IREDELL COUNTY HEALTH DEPARTMENT

IMPROVEMENT PERMIT / AUTHORIZATION TO CONSTRUCT / OPERATION PERMIT / EXISTING SYSTEM

EXPEDITED REVIEW PROCESS LOW PRESSURE MANIFOLD DOSING
FOR A
25% REDUCTION SEPTIC SYSTEM
FOR
SUBSURFACE WASTEWATER DISPOSAL
FALLS PARK SUBDIVISION
CORNER MORRISON FARM AND DAYVAULT CUT – LOT 1
TROUTMAN NC

Re: Application for improvement permit for Livewell Homes property site 106 Daywault Cut Rd. Health Department file number 216195.

INITIAL SITE SKETCH

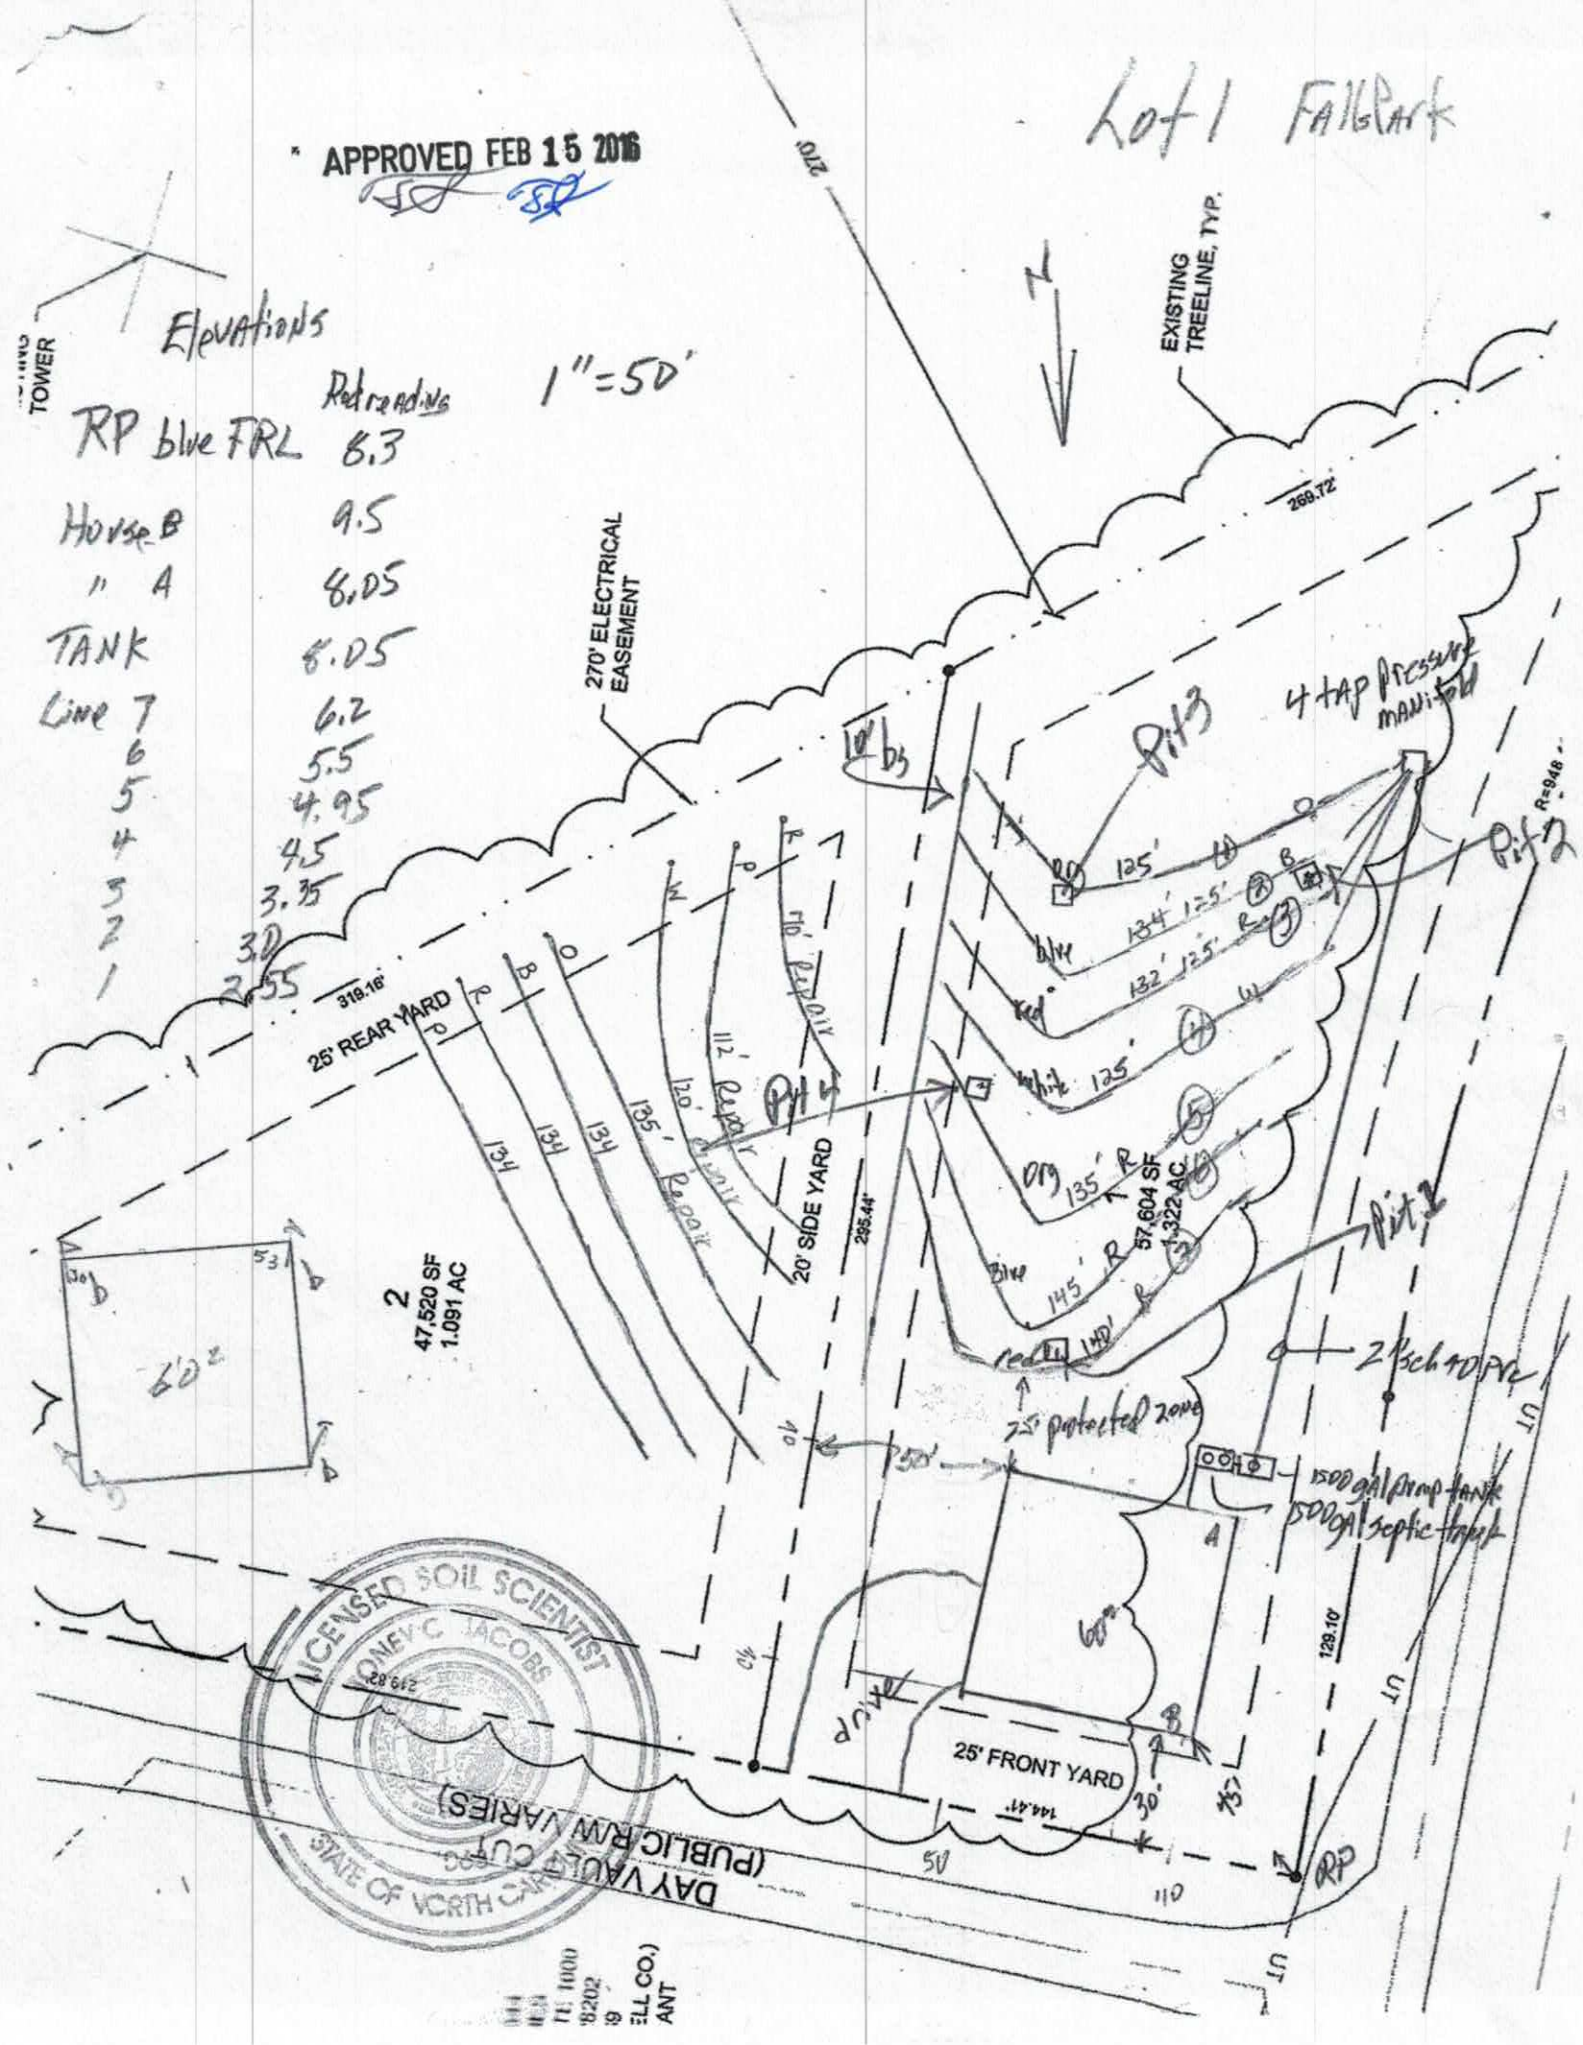
Comments / Conditions: Recommend pumping septic tank every 3-5 years. Strongly recommend limiting the pumping of the pump chamber to 60% → 70% of design flow (360-420 gals/day) vs. the currently proposed 600 gallons/day (100% design flow)

SOIL/SITE EVALUATION
***for* ON-SITE WASTEWATER SYSTEM**
(Complete all fields in full)

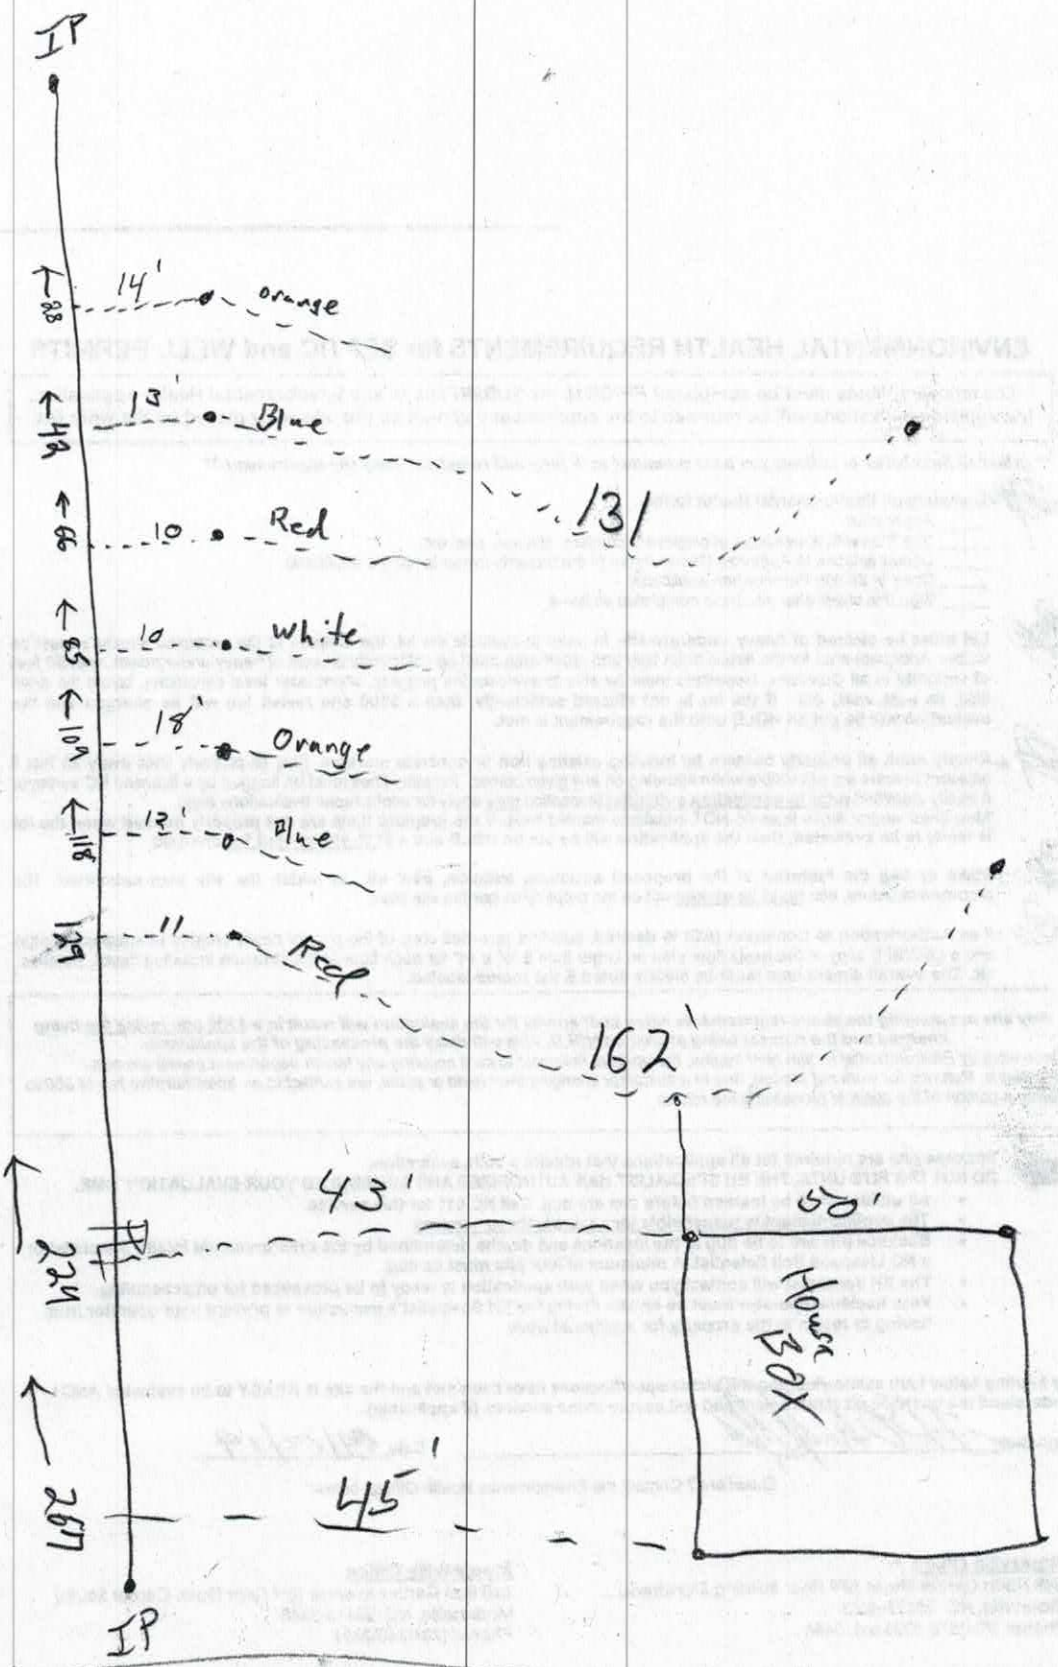
X NCDENR Soil/Site Evaluation form not submitted and/or (properly filled out)

X Other: Soil test pits not legibly marked on site sketch (#s)
